Transmission Output Shaft Nut Loosening

Source: Eaton/Roadranger Service Bulletin TMIB-0193
The material contained in this bulletin is product improvement information. Eaton and Dana Corporation are not committed to, or liable for, canvassing existing products.
FSUD: 2010-FSUD-1375

NEW OUTPUT SHAFT NUT (4306520)

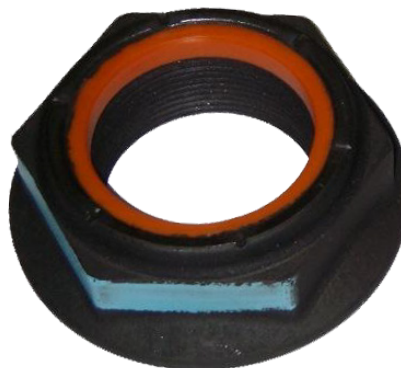
The new output shaft nut (4306520) will prevent loosening and maintain the installation torque. The new nut has a crimped crown that creates interference between the output shaft threads and the nut. In addition, there is a locking compound applied to the threads of the nut.

Note: The new nut with the crimped crown requires a higher torque rating than the old nut. The higher torque is needed to seat the nut completely.

If output nut 4302321 loosens, replace it with 4306520 and torque nut to 650-700 lb-ft.
